DR Tx 'off' specs (comment 129, 130)

IEEE P802.3cd, March 2017, Vancouver BC

Jonathan King, Finisar

Tx 'off' spec for multi-lane SMF

200G DR4, 400G DR4 & 100G DR specs, proposal 1: -14, -13 and -13 dBm Tx 'off' spec

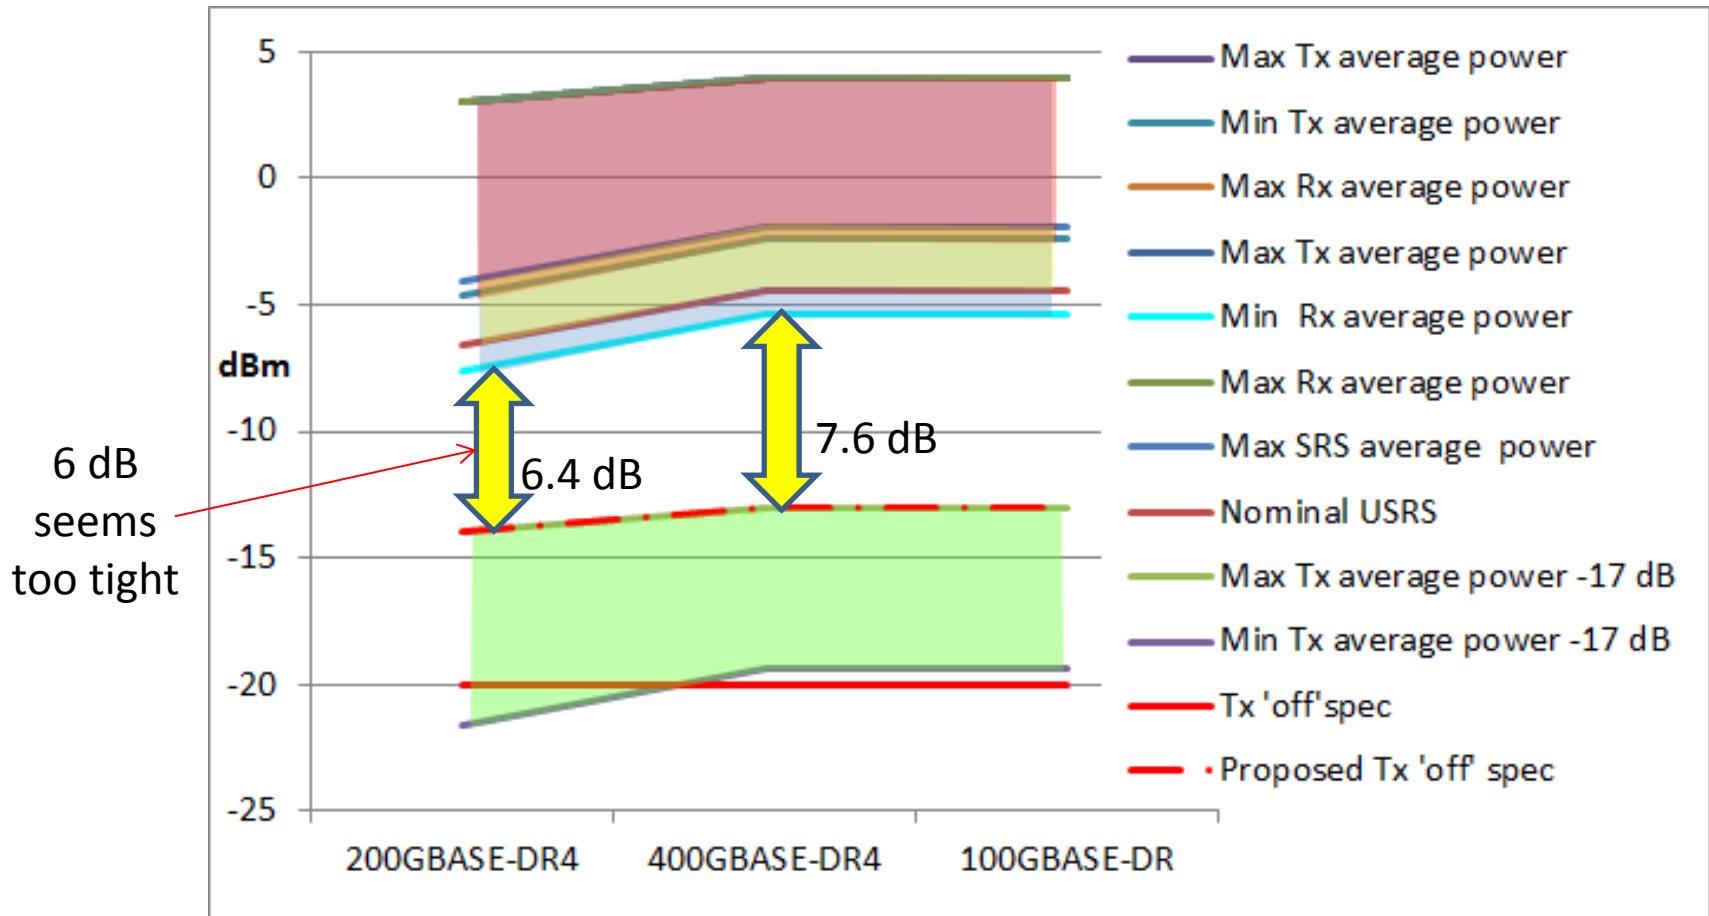
20 dB min extinction from modulator would allow 17 dB reduction in average Tx power

200G DR4, 400G DR4 & 100G DR specs proposal 2: -16, -15 and -15 dBm Tx 'off' spec

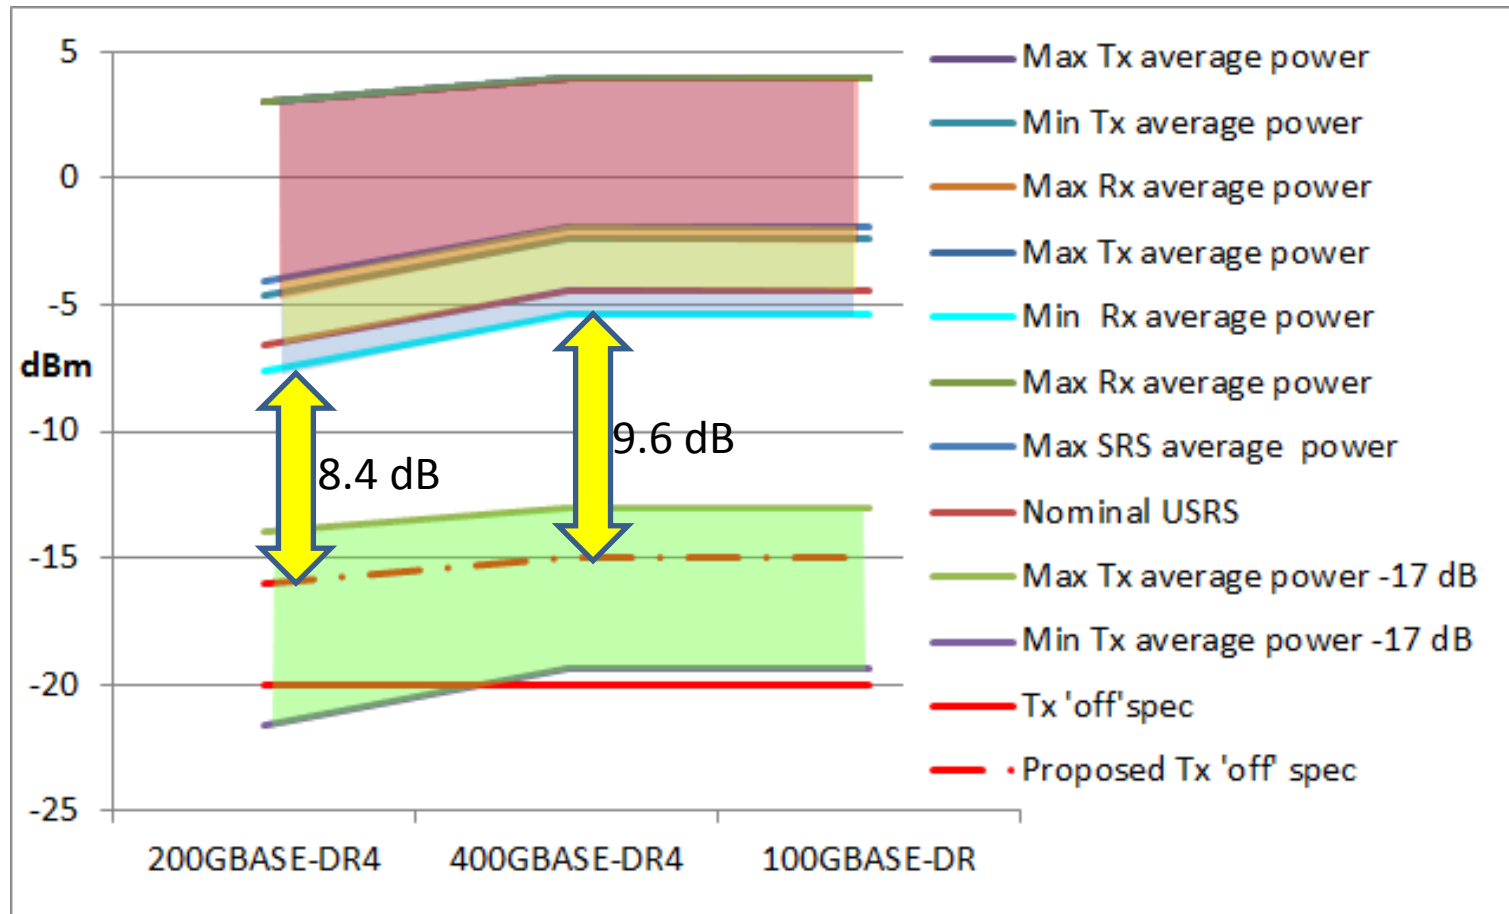
20dB min extinction from modulator would allow 17 dB reduction in average Tx power
Meeting Tx 'off' spec relies on controlling lane to lane Tx average power per lane

200G DR4 & 50G FR, 400G DR4 & 100G DR specs proposal 2: -16, -15 and -15 dBm Tx 'off' spec

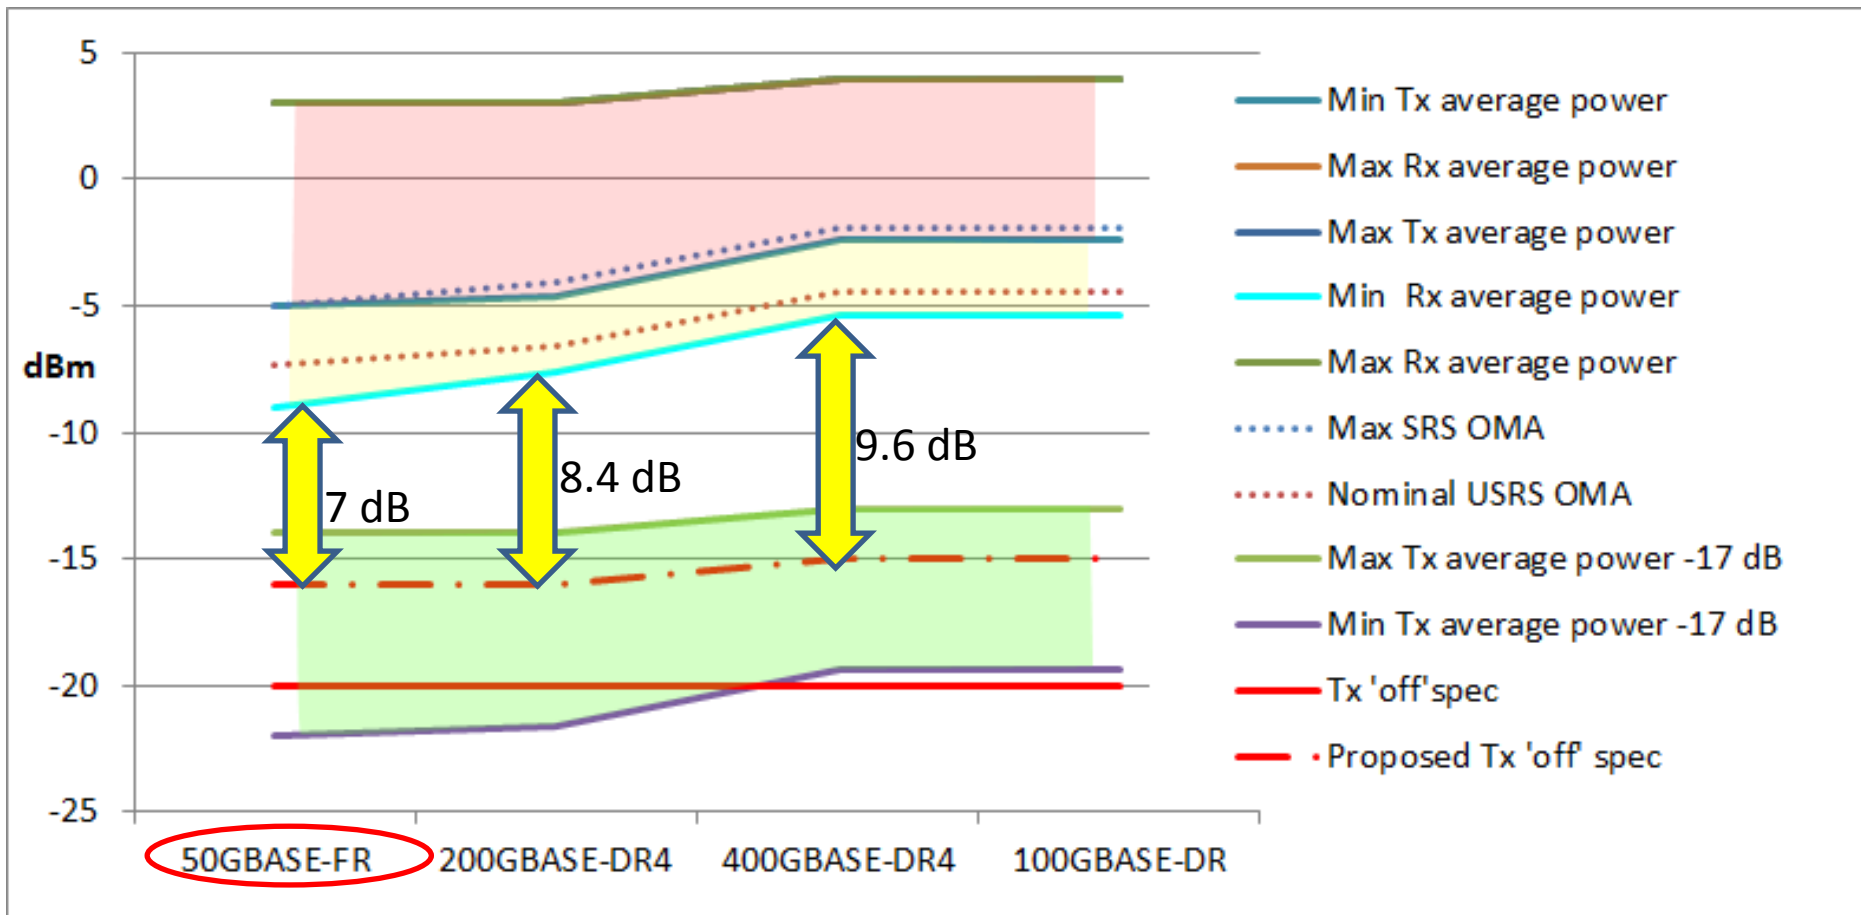
20 dB min extinction from modulator would allow 17 dB reduction in average Tx power
Meeting Tx 'off' spec relies on controlling lane to lane Tx average power per lane very closely

50GBASE-FR 'Average launch power, min' vs ER at -2 dBm OMA

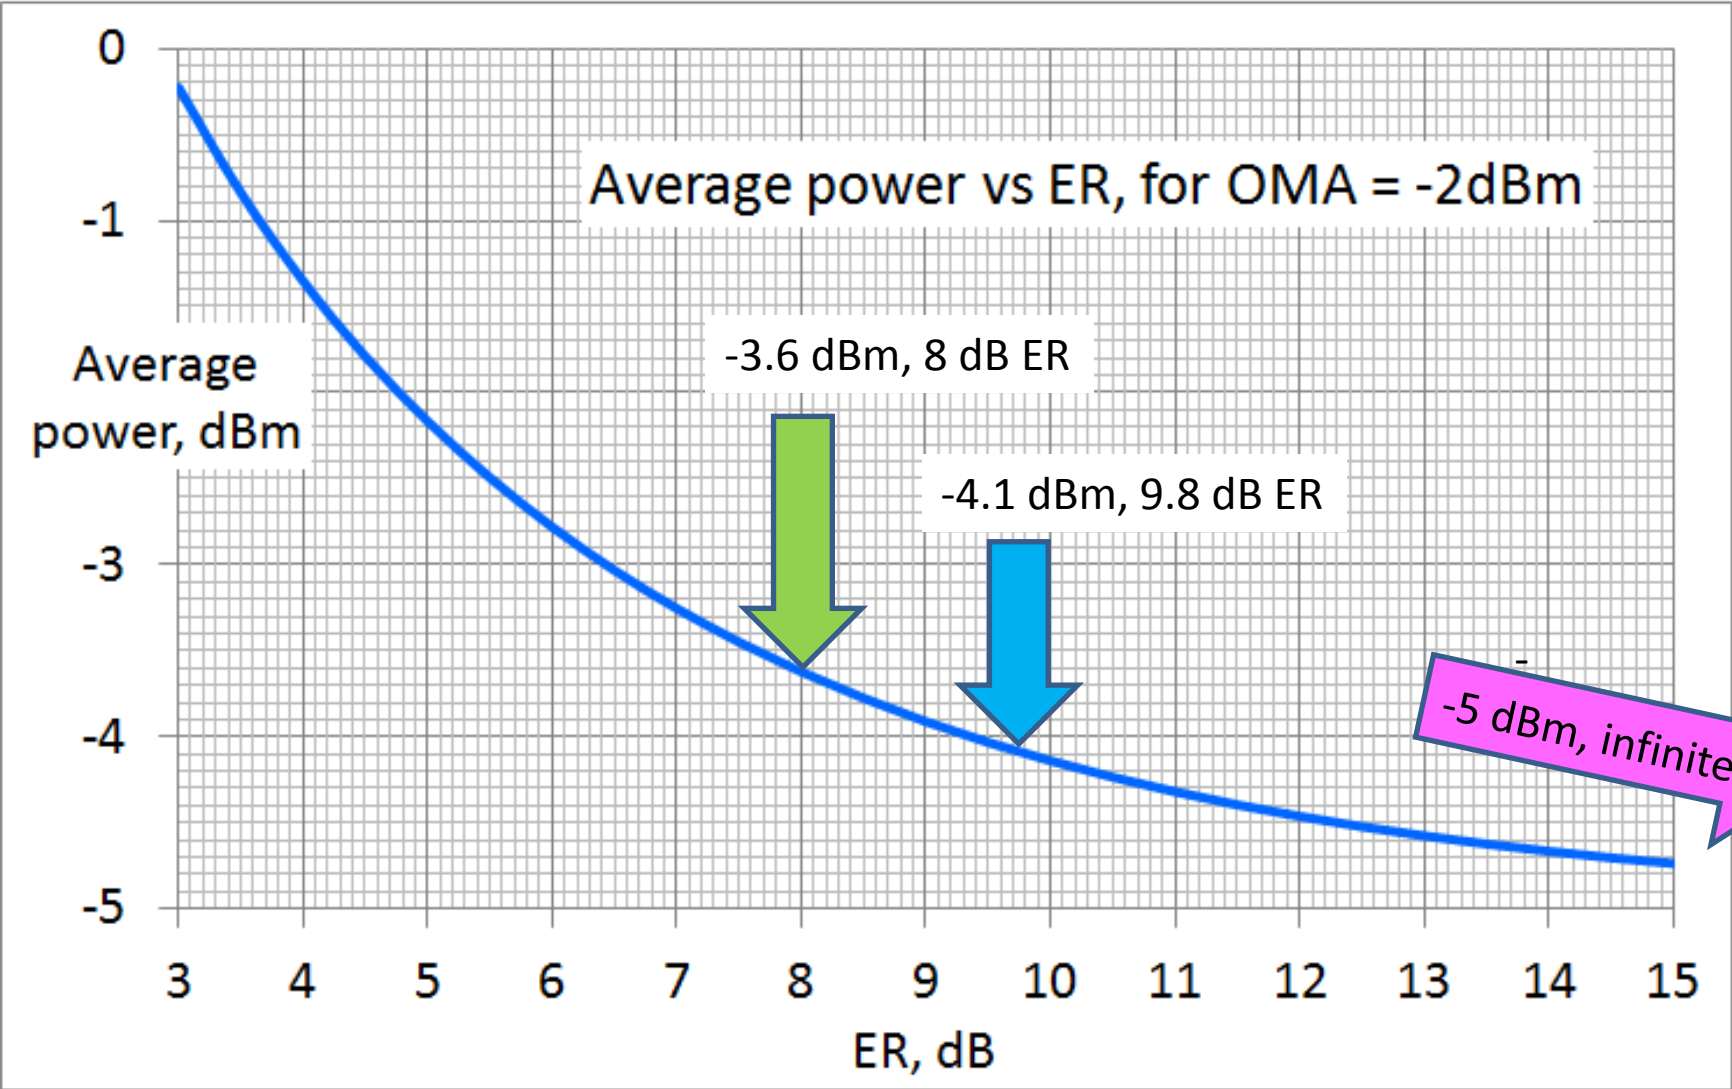
- Other DR and DR4 PMD specs have calculated the min Tx average power from the min Tx OMA and an assumed max ER of 9.8 dB.
 - 50GBASE-FR uses an infinite ER assumption.

- **Option 1:** For 50GBASE-FR, **use same assumed 9.8 dB ER** as other PMDs, to raise the min Tx average power from -5 dBm to -4.1 dBm.
 - 'Average received power each lane (min)' would increase to -8.1 dBm.

- **Option 2:** Use a higher **assumed ER of 8 dB** for 50GBASE-FR: raises the min Tx average launch power from -5 dBm to -3.6 dBm, and increases the 'Average received power' to -7.6 dBm, i.e. **same value as for 200GBASE-DR4.**

200G DR4 & option 1 50G FR, 400G DR4 & 100G DR specs proposal 2: -16, -15 and -15 dBm Tx 'off' spec

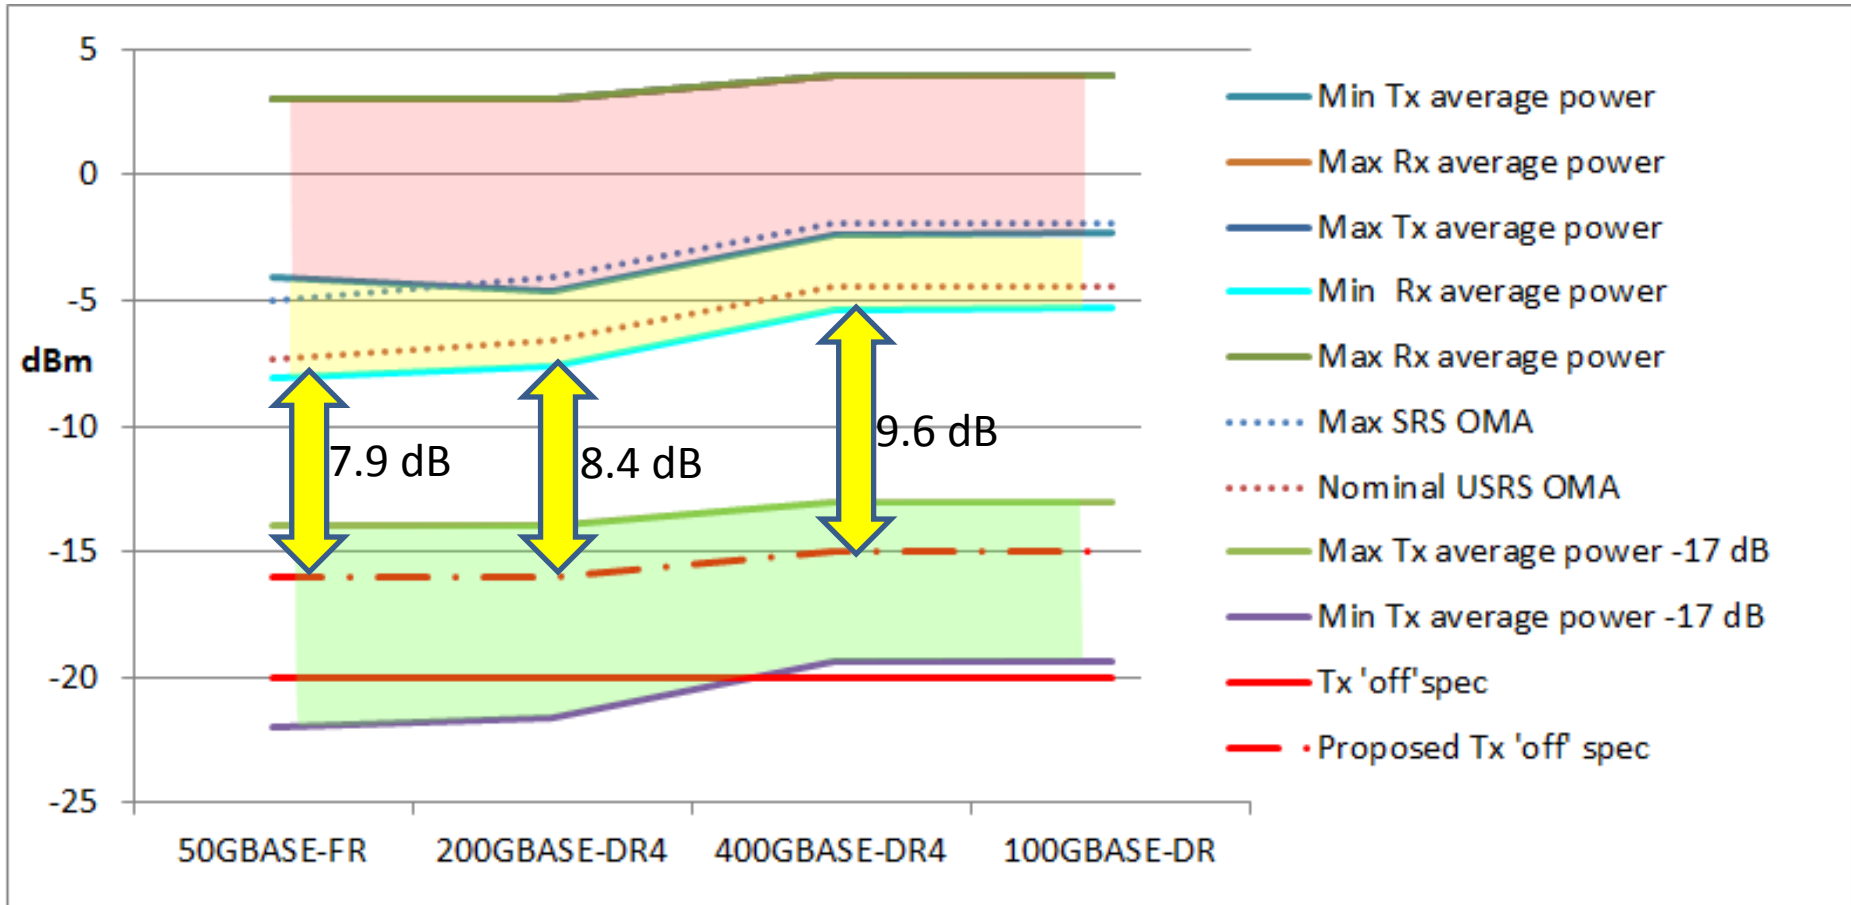
20 dB min extinction from modulator would allow 17 dB reduction in average Tx power
Meeting Tx 'off' spec relies on controlling lane to lane Tx average power per lane

200G DR4 & option 2 50G FR, 400G DR4 & 100G DR specs proposal 2: -16, -15 and -15 dBm Tx 'off' spec

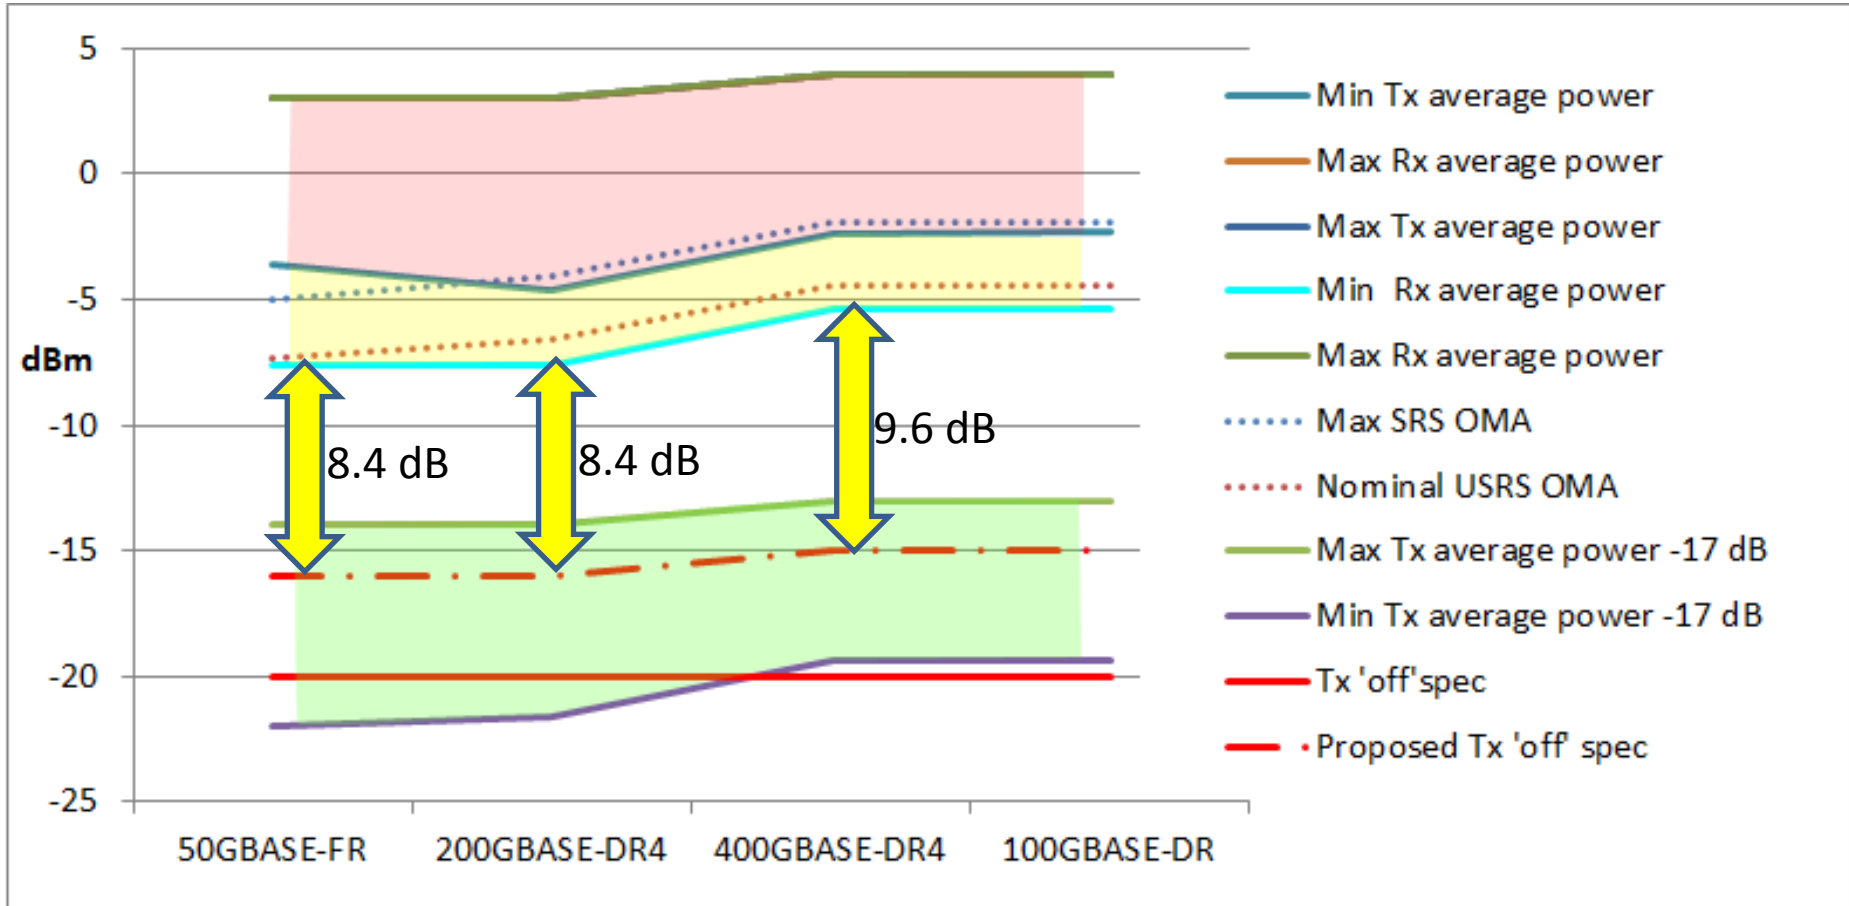
20 dB min extinction from modulator would allow 17 dB reduction in average Tx power
 Meeting Tx 'off' spec relies on controlling lane to lane Tx average power per lane
